Sunnyside Cogeneration Associates

RE: Sunnyside Refuse and Slurry C/007/0035
Request for Phase 1 Bond Release –
Excess Spoil Disposal Area #2 Phase 1 Reclamation

Permittee: SUNNYSIDE COGENERATION ASSOCIATES
Mine: SUNNYSIDE REFUSE & SLURRY **Permit Number:** C/007/035
Title: Excess Spoil Disposal Area #2 Ph 1 Area - Request for Phase 1 bond release

SHEET 5-2

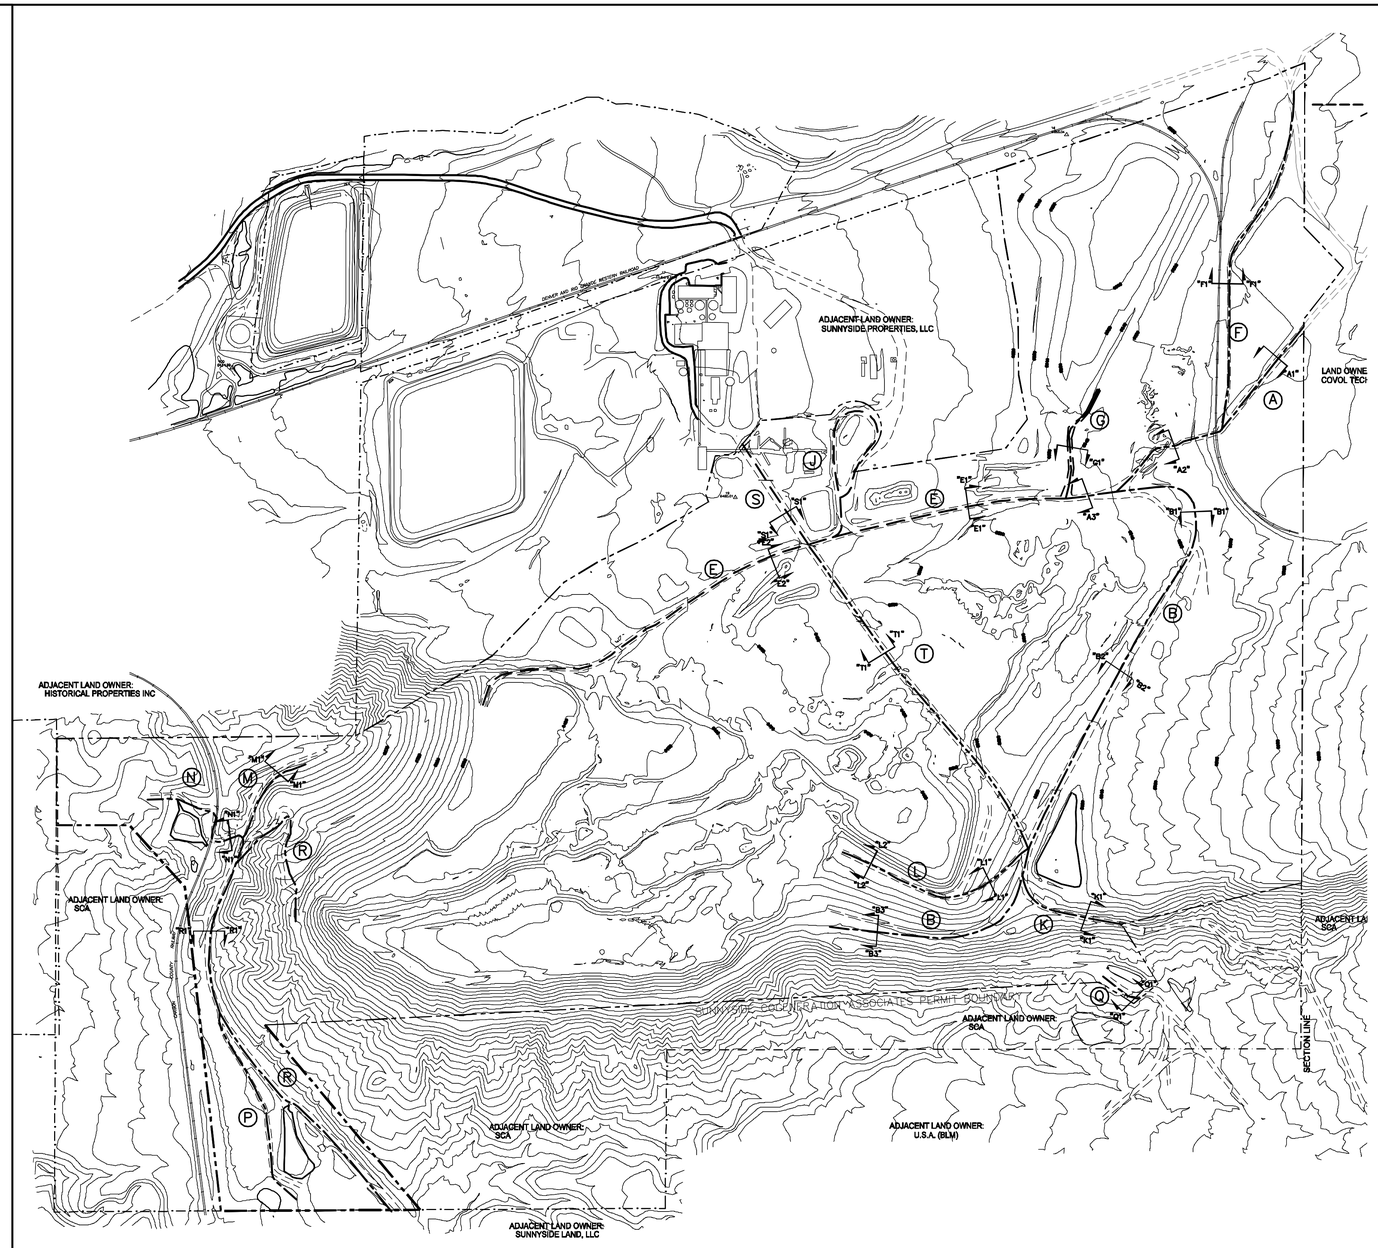
REV	DATE	DESCRIPTION	BY	APP'D
10	1/16	ROAD RECLAMATION UPDATES	AH	
9	7/15	WEST PASTURE AND REFUSE PILE ACCESS ROADS	AH	
8	11/10	BOUNDARY AND TOPO UPDATE	AH	
7	2/07	CHANGE IN ROAD H	AH	
6	9/02	2002 PERMIT RENEWAL	PAM	
5	9/94	CHANGE IN ROAD B AND R	AJZ

SHEET 5–2D

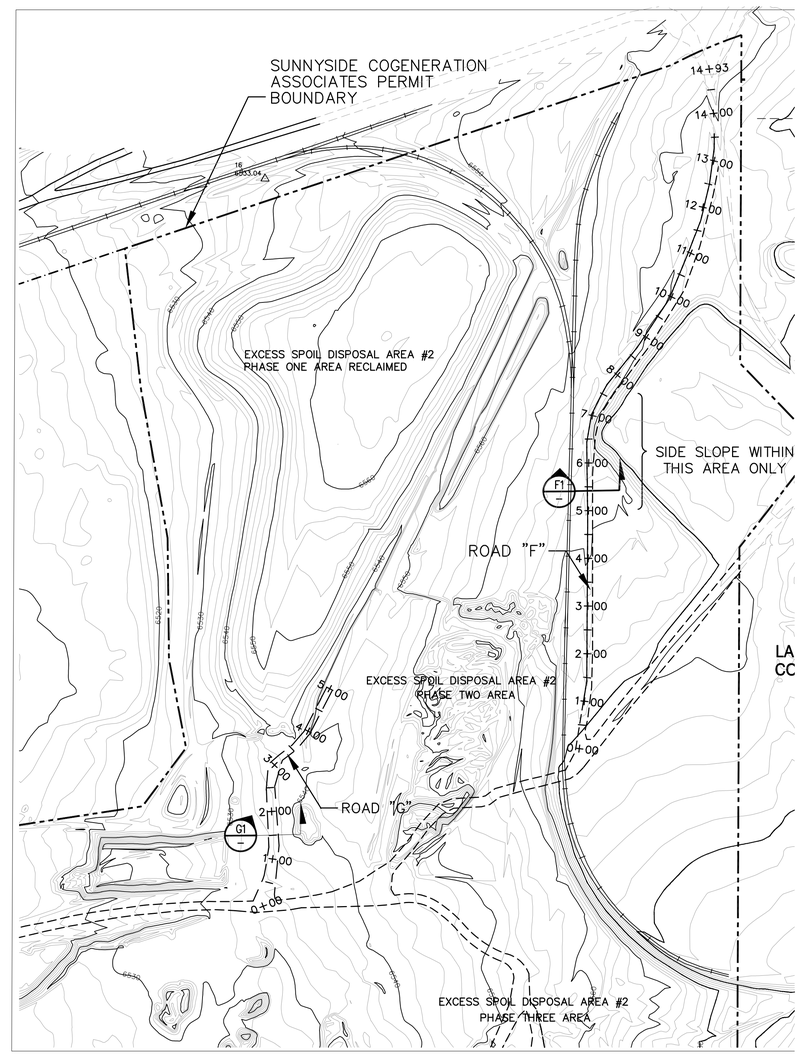
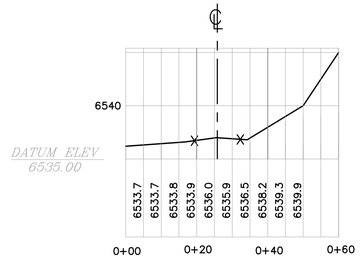
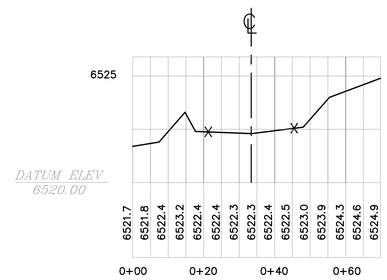
F. Railroad Access Road is located in the northeast portion of the permit area and provides access to this portion of the permit area
G. Excess Spoil Disposal Area #2 Road is located in the northeast portion of the permit area ~~between the~~and provides access to the Excess Spoil Disposal Area #2~~ and the coke ovens. This road provides access to the reclaimed disposal area and drainage features in the area for inspection and monitoring~~.
~~I. Clear Water Pond Access Road is located in the northeast portion of the permit area near the Excess Spoil Disposal Area #2 (former Clear Water Pond was in this area). This road provides access around the reclaimed disposal area.~~

REV	DATE	DESCRIPTION	BY	APP'D
5				
5	1/16	ROAD RECLAMATION UPDATES	AH	
4	11/10	BOUNDARY AND TOPO UPDATES	AH	
3	9/02	2002 PERMIT RENEWAL	PAM	
2	9/97	PERMIT RENEWAL– UPDATE	CAC	
1	2/94	REVISED SECTIONS	AH

7-1

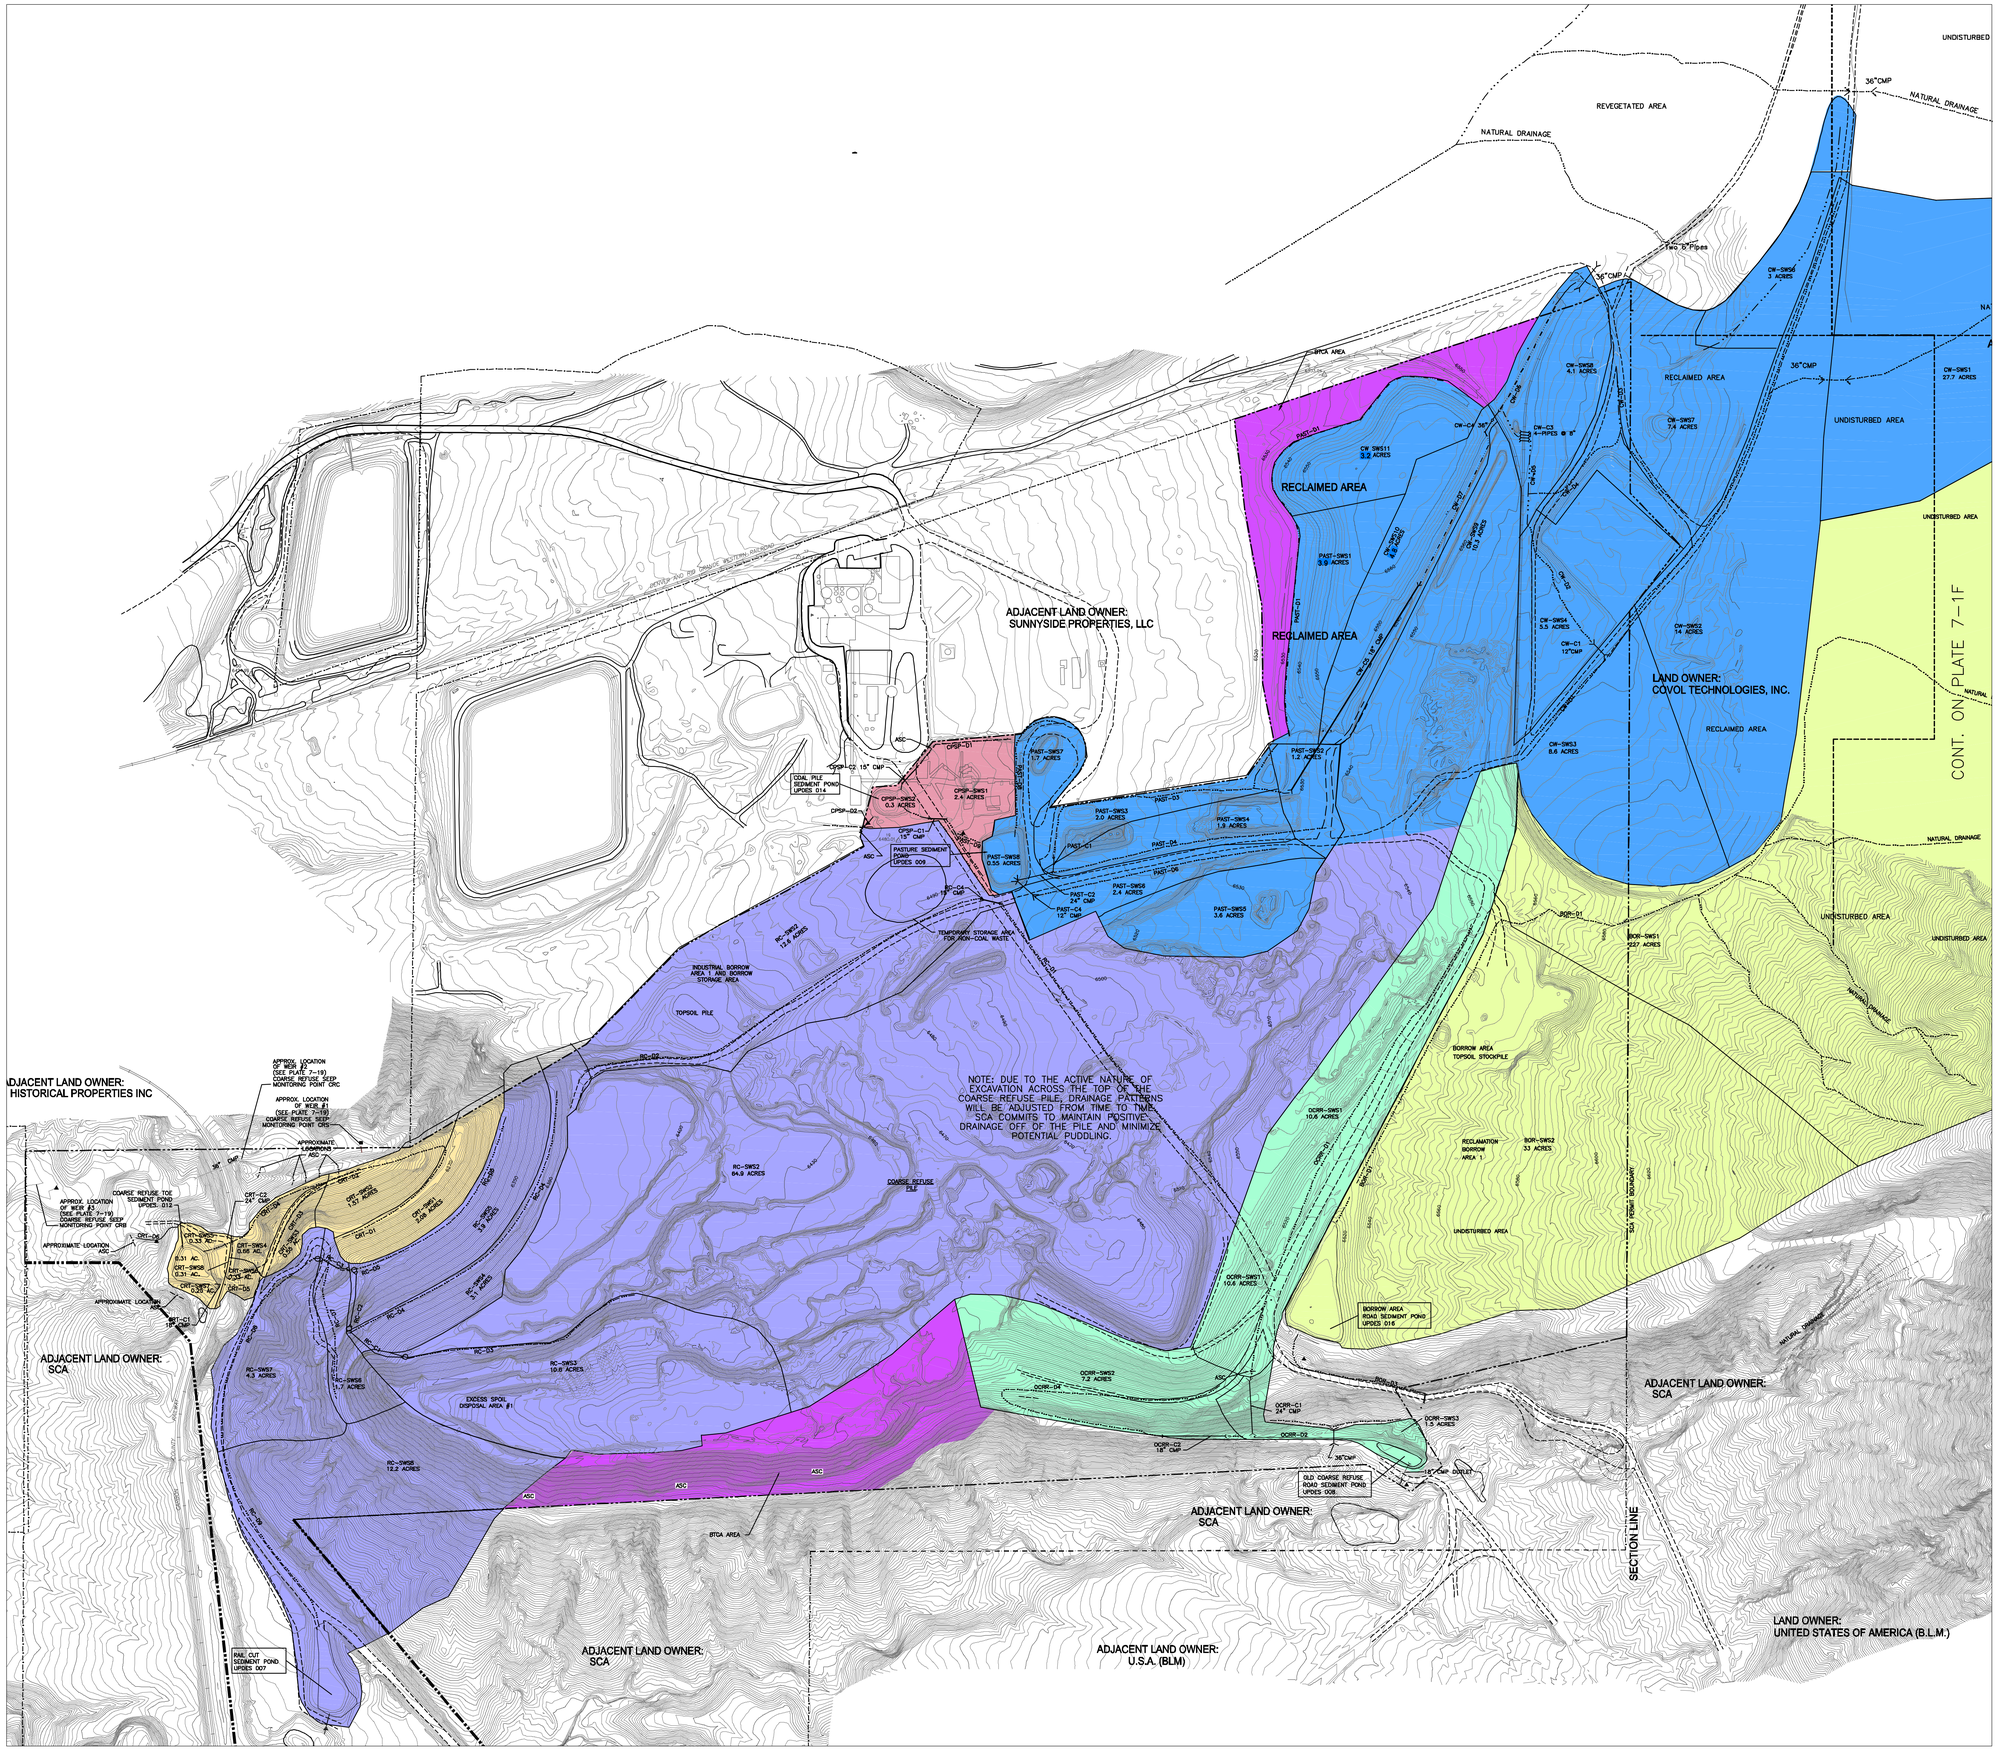
REV	DATE	DESCRIPTION	BY	APP'D
17	1/16	EXCESS SPOIL DISPOSAL AREA RECLAMATION UPDATE	AH	
16	7/15	REMOVE CULVERTS IN PASTURE POND DRAINAGE AREA	AH	
15		ADD DITCHES AND CULVERTS IN RAIL CUT DRAINAGE	AH	
14	11/10	BOUNDARY UPDATE	AH	
13	8/10	UPDATE SITE AND TOPO	AH	
12	5/08	MOVE PASTURE POND CULVERT-C1	SSC	
11	5/07	UPDATE PASTURE POND	AH	
10	3/06	UPDATE DRAINAGE AREAS	AH

8–1

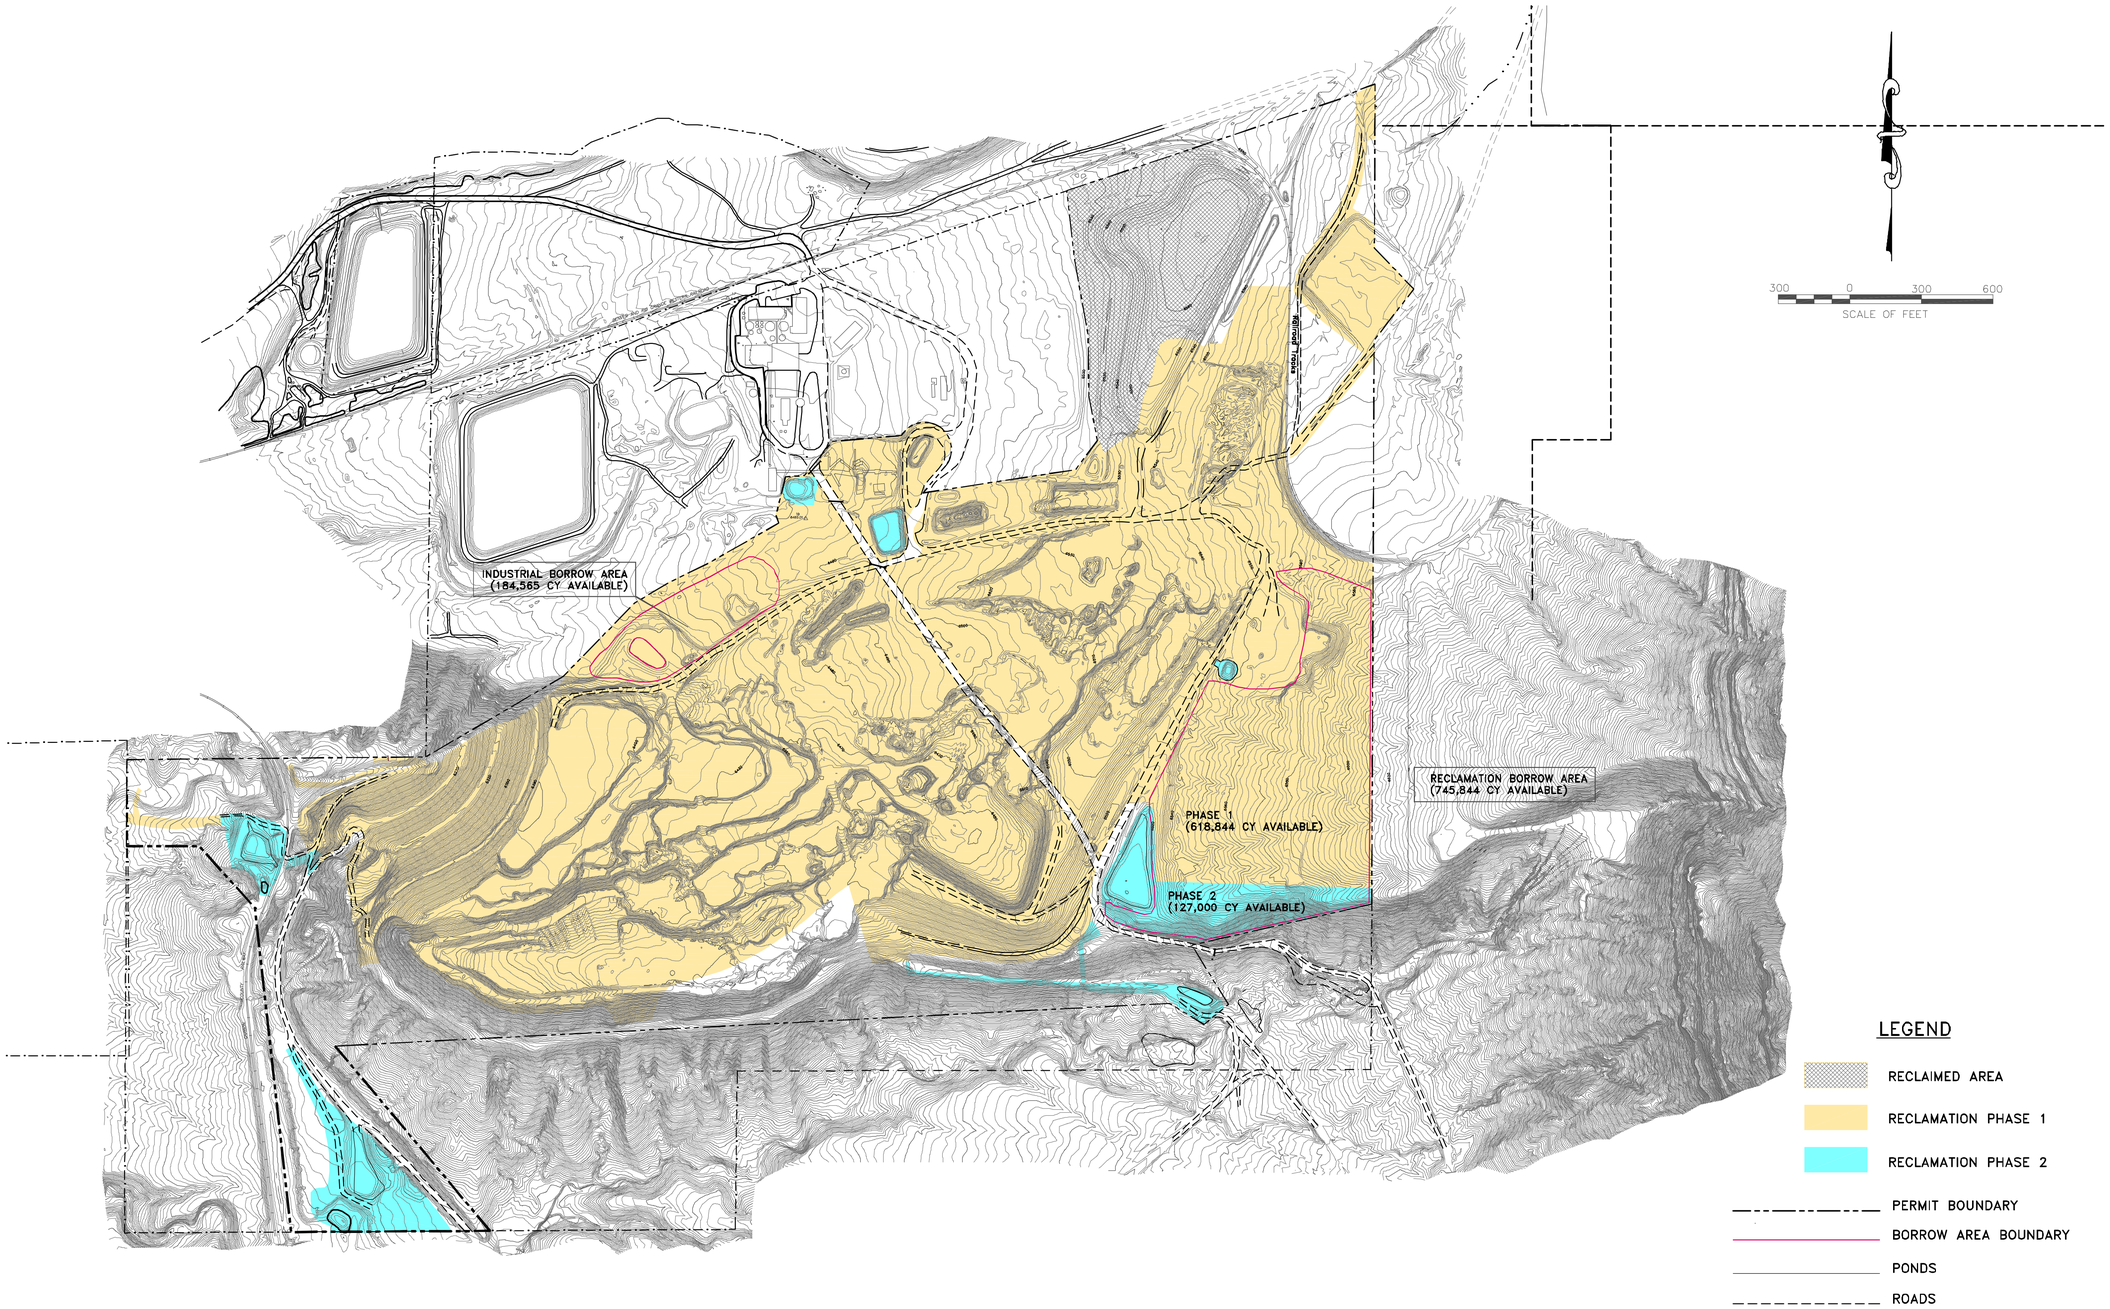
REV	DATE	DESCRIPTION	BY	APP'D
5	1/16	EXCESS SPOIL DISPOSAL AREA 2 PH 1 RECLAMATION UPDATES	AH	
4	6/11	EXCESS SPOIL DISPOSAL AREA 2 CHANGES	AH	
3	11/10	BOUNDARY AND TOPO UPDATES	AH	
2	9/02	2002 PERMIT RENEWAL	AH	
1	9/97	PERMIT RENEWAL– UPDATES	AH
